TITLE:
Car Park Level -1 Floor Plan Sheet 1

PROJECT:
**Project No. 11581
Kidderpore Avenue**

SCALE: A1@ 1:100 DATE: Nov 15 DRAWN: SK CHKD: TP
DRG NO. REV.
9100-DRG-03ZZ-BO900 A

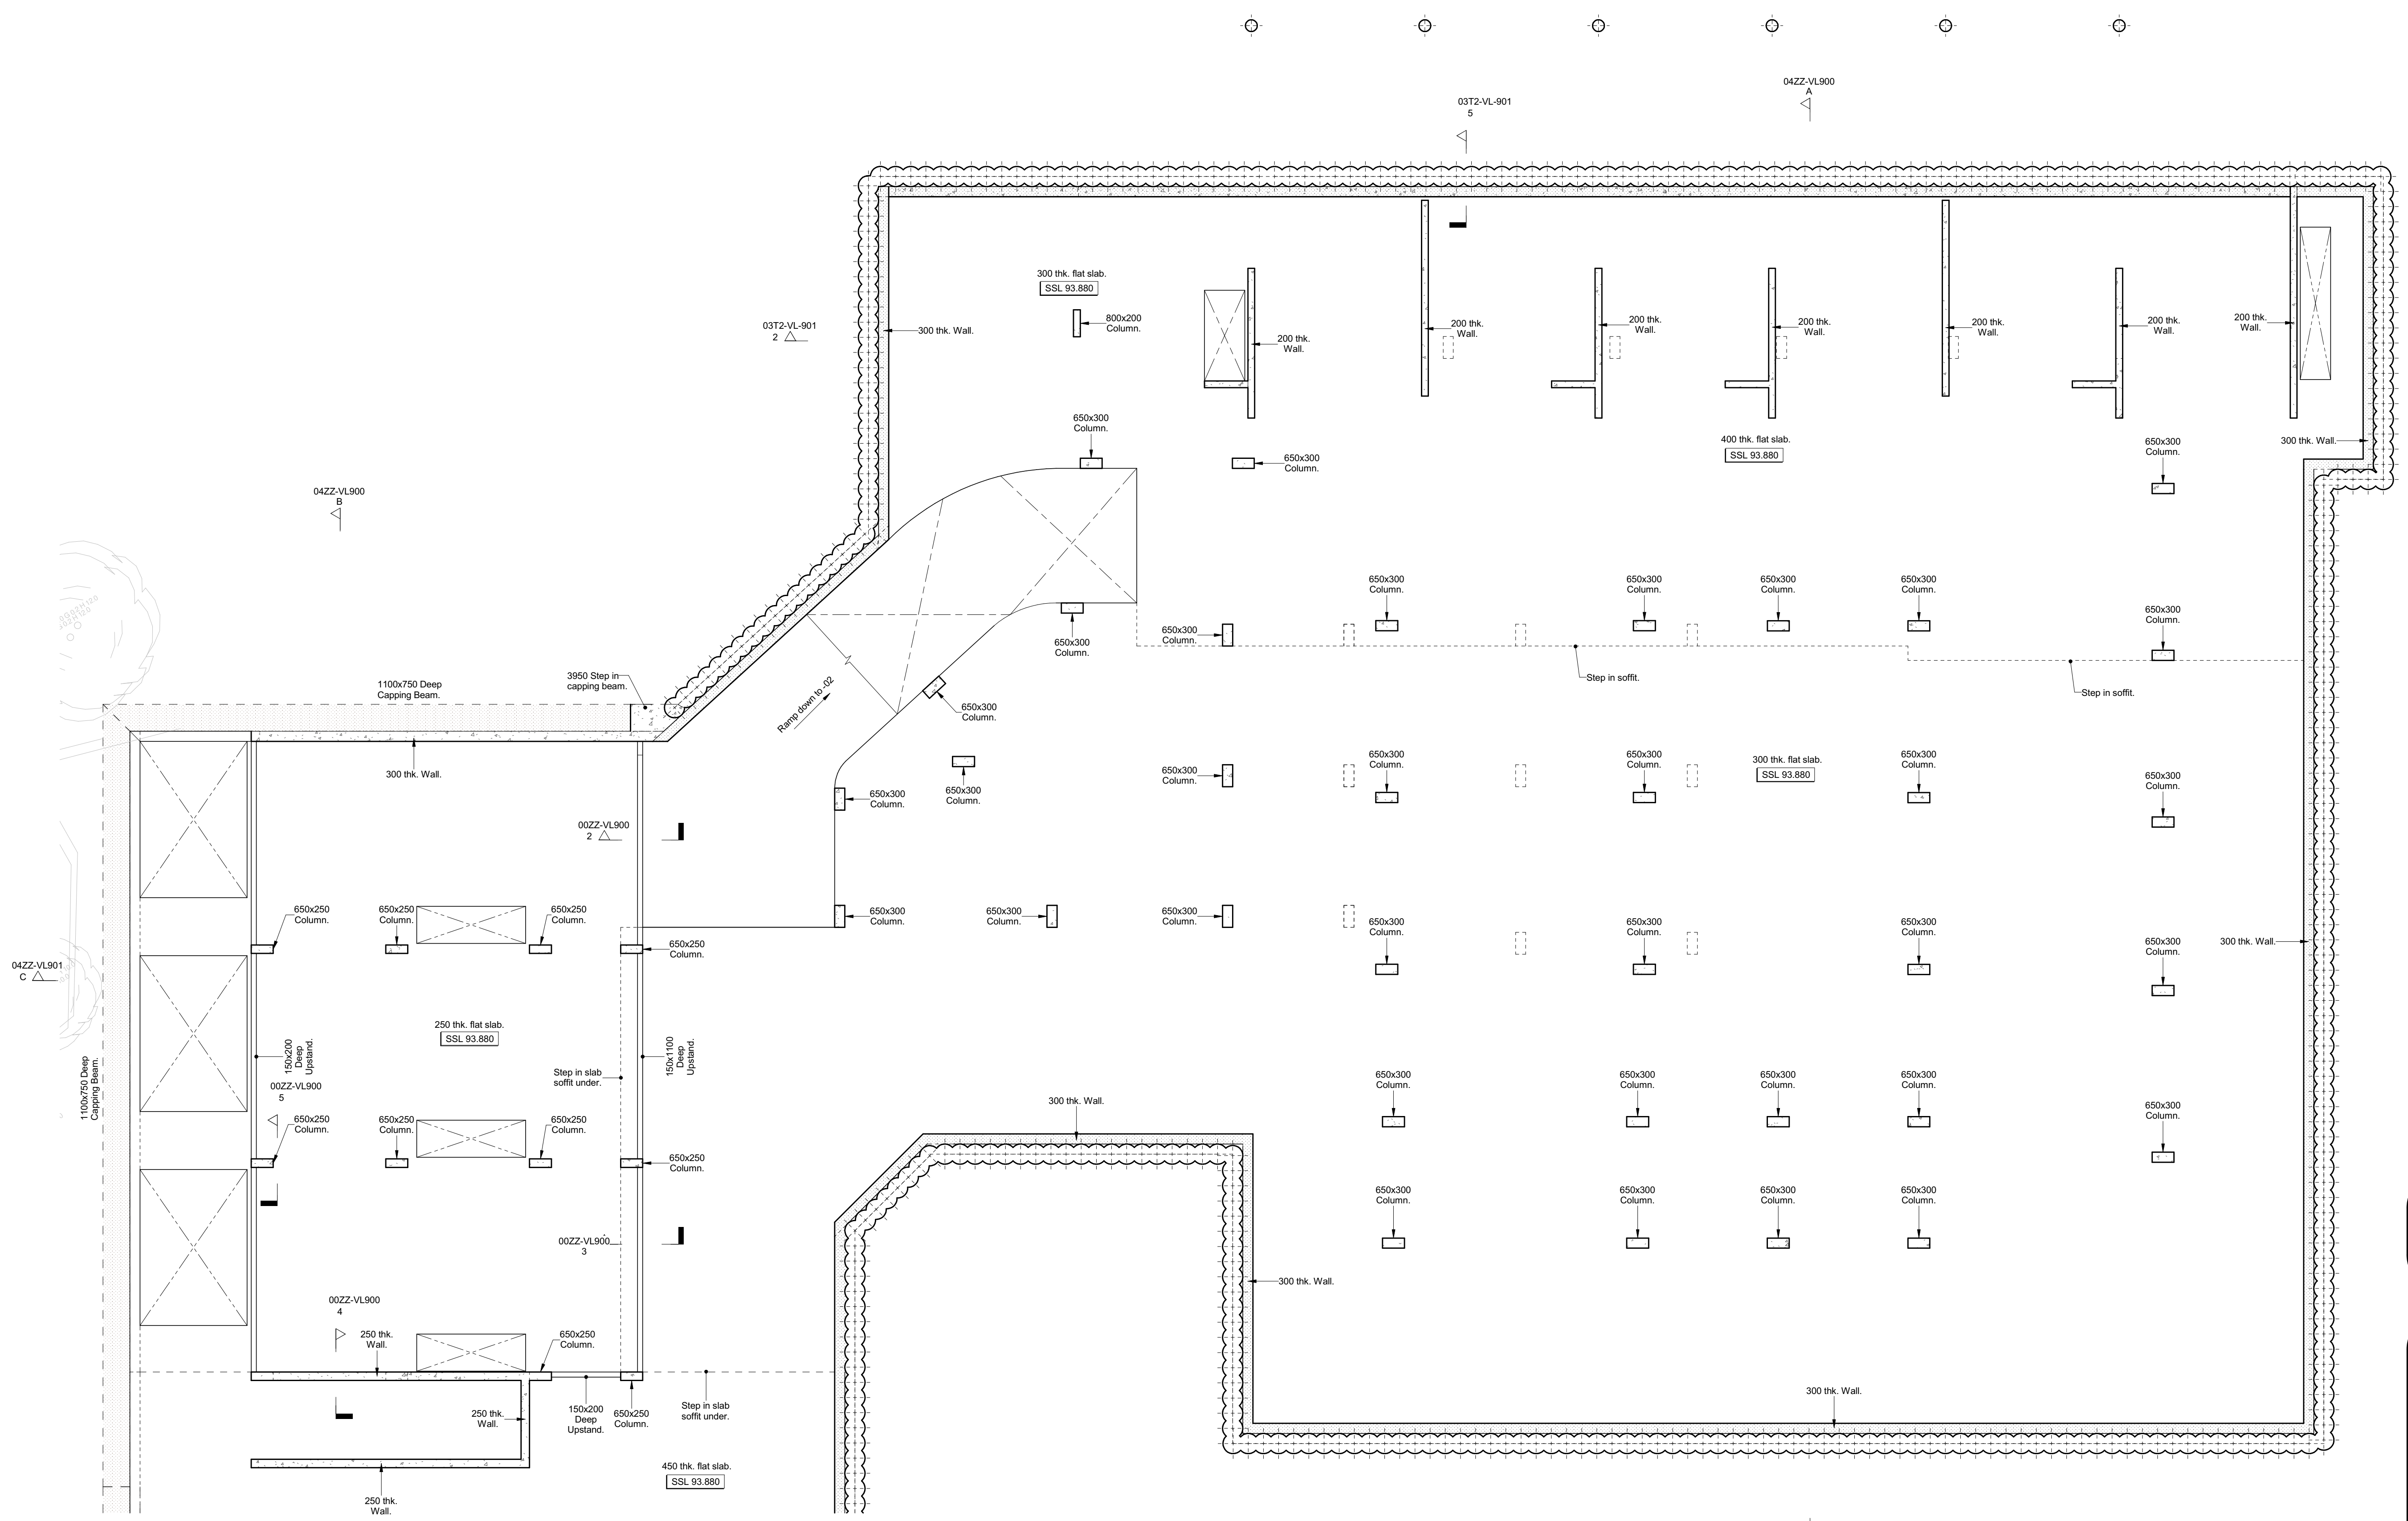
NOTE
WATERPROOF STRATEGY FOR BASEMENT LEVEL TO BE CONFIRMED BY ARCHITECT.

NOTE
TRANSPORT CONSULTANT TO REVIEW AND CONFIRM STRUCTURAL LAYOUTS ARE ACCEPTABLE VEHICLE MOVEMENTS.

NOTE
RC LINER WALL TO FACE OF PILED RETAINING WALL TO BE FORMED USING WATERPROOF CONCRETE.

NOTE
PROVISIONALLY ALLOW FOR CAPPING BEAM TO BE FORMED IN WATERPROOF CONCRETE SUBJECT TO WATERPROOF STRATEGY.

A 26.02.16 Waterproof concrete indicated. Piles to town houses added and pile table updated. Box notes updated. Drawing number revised to comply with clients document control system requirements.
